Query #	Section	Page ref	Comment from Peer Review	Consultant Team's Response	Detailed Design Document Reference / Detail
Fire & Smoke Control in Buildings – Two MS, Report No: 01630, Rev A, 24 July 19 Response led by Northrop with input from Core Engineering					
1	1	7	Missing stair pressurisation relief system for the fire isolated stairwells. This is a critical part of the required Smoke Hazard Management and must be implemented to the full requirements of BCA 2016 Amendment-1, Part E2.2, and referenced Australian and New Zealand Standard AS/NZS1668.1-2015.	Further detail is now provided to confirm stair pressurisation relief will be achieved via natural relief openings from louvres at both ends of all floors, in accordance with BCA 2019 and AS1668.1:2015. The size and type with details is shown in further developed mechanical drawing number GIB-MD31700-[Rev A] Level 17 HVAC Layout	
2	2	7	Missing Zone Pressurisation System for the Ground Floor Class 5 and 6 Tenancies. This is critical and is required under the DTS provisions of BCA 2016 Amendment-1, Part E2.2, and referenced Australian and New Zealand Standard AS/NZS1668.1-2015. Alternatively, a Fire Engineered Performance Based

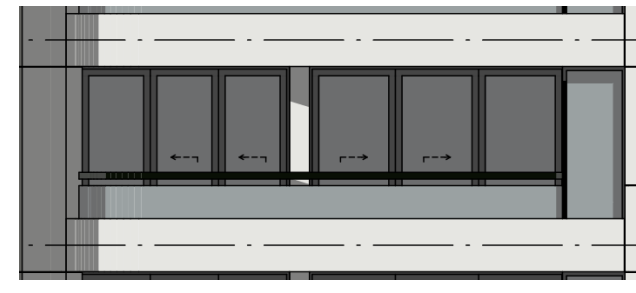
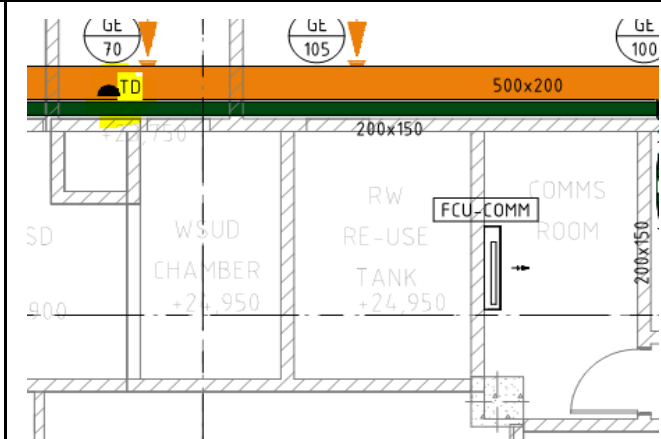
Query #	Section	Page ref	Comment from Peer Review	Consultant Team's Response	Detailed Design Document Reference / Detail
14	3.1	5	No functional description document detailing a control strategy was provided, however, there is a sketch (Image 2 below) and the following paragraph given in the document extract provided by NSW IPC entitled "3 Response to issues raised pages 9 – 18.pdf" (italics are the author's)	<p>As part of design development, the following functional description is documented in Northrop Mechanical Performance Specification. Excerpt for COAS below;</p> <p>The central outside air fan will run on a time clock. The system can be centrally controlled to reduce speed and/or shut down for periods of time to assist with managing comfort during unfavourable ambient conditions.</p> <p>Air will be tempered as required during winter months using a gas fired heating hot water generator. Temperature setpoints will be adjustable for future amendments and controlled via outside temperature sensors and supply air temperature sensor.</p>

18	3.2	6	The sketch in Image 2 above indicates that the Invisivent trickle ventilation system is being proposed as a path for relief air, with supply air being provided by the COAS system. However, a review of the Invisivent brochure indicates that the product seems to be designed to be used in a supply configuration.	The proprietary trickle ventilation system Invisivent offers both make-up and relief paths, as confirmed by manufacturer.	
19	3.2	6	<p>All Invisivent product representations in their brochures show installation above a DGU (double glazed unit) window system.</p> <p>Is the installation of this product appropriate above a single glazed window system framing as noted in the drawings?</p>	All residential windows have been specified on the plans and will be delivered as double glazed units to all the residential windows.	
20	3.2	7	Have fan performance curves been considered to meet the system pressures required to provide rated airflow capacity for the exhaust system ductwork configurations as proposed? The proposed duct runs are significantly longer than typical for such systems.	Appropriate exhaust fans have been selected to meet the ventilation system's requirements. Static pressure calculations will be completed by mechanical contractor as part of the Construction Certificate documentation.

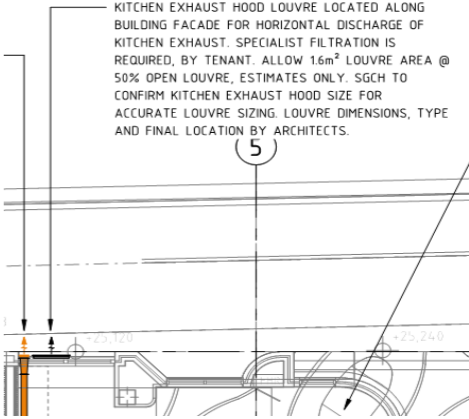
29	3.4	8	There is no tundish or adequate drainage shown for the comms room FCU, and it is therefore non-compliant with AS366 microbial standard.	Further details of the tundish are provided in the Ground floor mechanical drawing, GIB-MD-20000-[Rev A] - indicated in yellow in the adjacent snapshot to comply with AS366 microbial standard.
